PUBLIC HEARING/WORKING SESSION MEMORANDUM

PETITIONS #26-20 & #27-20

355 and 399 Grove Street

To: Jennifer Caira and Neil Cronin, Planning and Development Department, City of Newton
From: Green International Affiliates, Inc. (Green)
Date: April 3, 2020
Project Name: Riverside Station
Project Number: Green No. 18078
Subject: Responses to City Council Questions

Graphic II: Building 5 Section in Alternative B

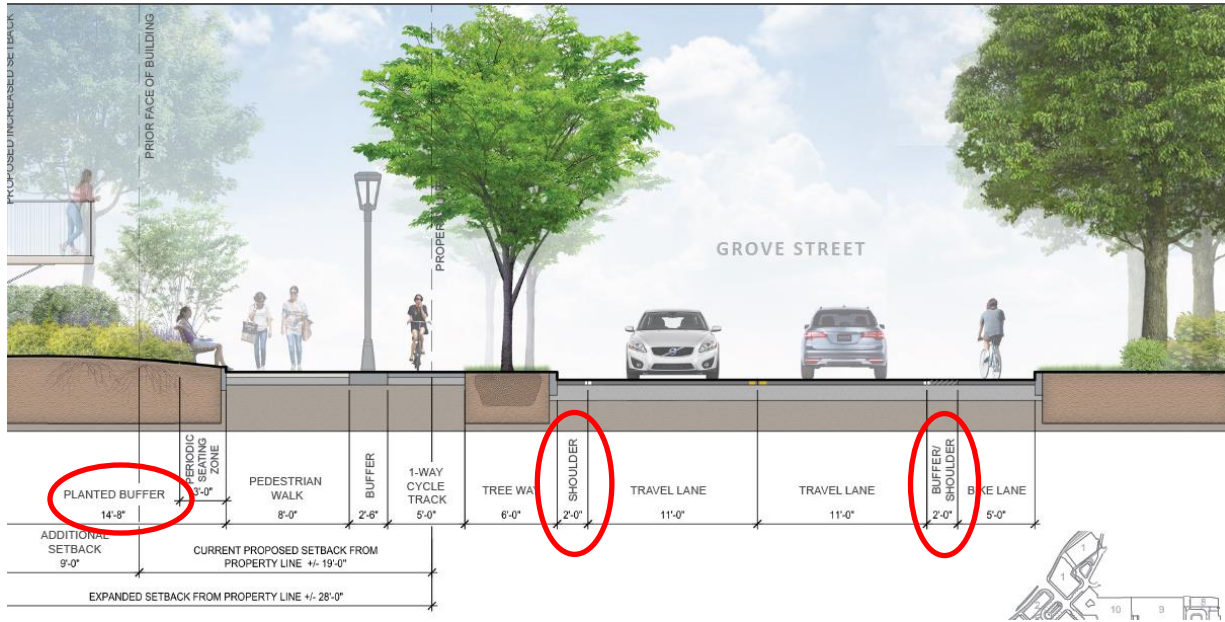
Due to comments at the February 25th meeting, the petitioner provided two alternatives for the Grove Street bicycle lanes: Alternative A includes both the two-way bicycle lane and the one-way bicycle lane; Alternative B reduces the two-way cycle track on the western side of Grove Street to a one-way bicycle lane and maintains the one-way bicycle lane on the eastern side of Grove Street. Reducing the two-way bicycle lane to one-way, results in five feet of street width that can be reallocated. Reallocating that five feet, results in the following changes to Grove Street in front of Buildings 5 and 6:

- The area referred to as the “Planted Buffer” is increased by two feet, from twelve feet, eight inches to fourteen feet, eight inches;
- The shoulder east of the “Tree Way” is increased by one foot, from one foot to two feet; and
- The bike lane on the eastern side of Grove Street is “buffered” by two feet.

The Planning Department reviewed the two alternatives with members of the Transportation Division of Public Works and together, the group prefers Alternative A because of the reasons cited above, and because it is reasonable to expect an increase in short-term bicycle trips to the Project from the south. These trips are likely to utilize the two-way cycle track to access the site because they would not have to cross Grove Street. However, staff suggests the following modifications be made to Alternative A:

Graphic III: Building 6 Section in Alternative B

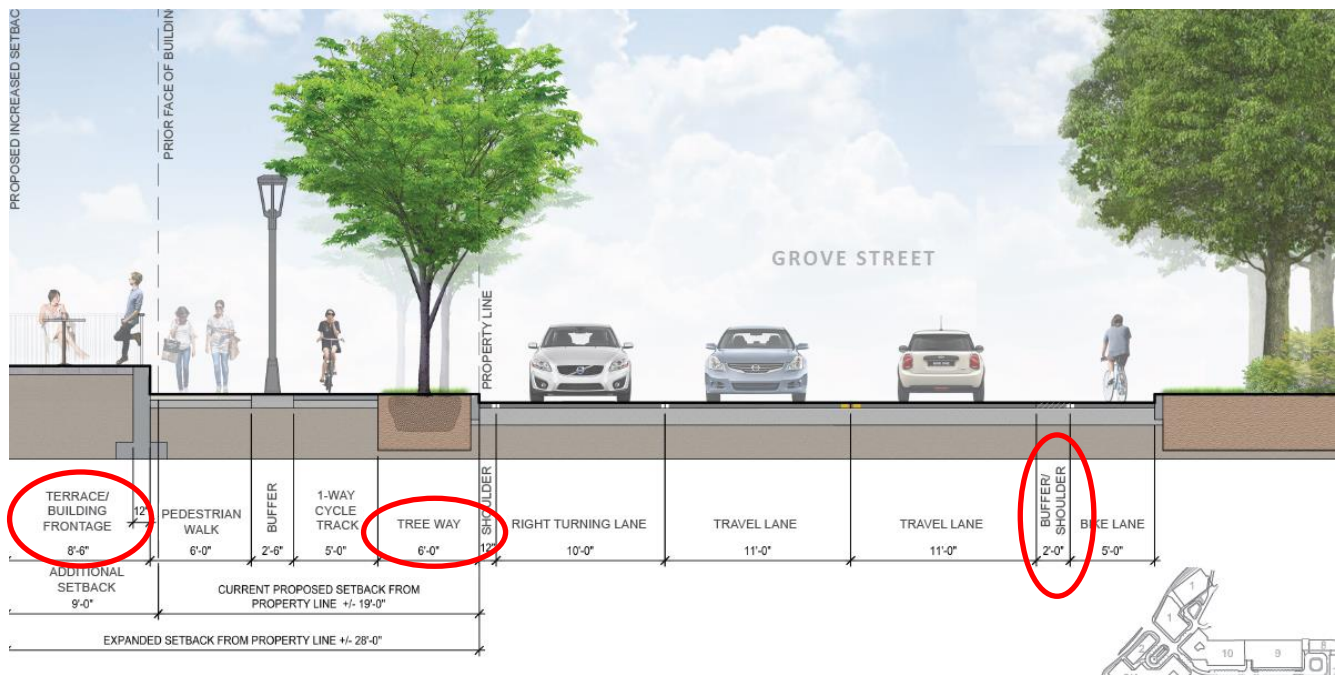
- The area referred to as the "Terrace/Building Frontage" adjacent to Building 6 is increased by two feet, from six feet, six inches to eight feet, six inches;
- The Tree Way is increased by one foot, from five feet to six feet; and
- The bike lane on the eastern side of Grove Street is "buffered" by two feet.
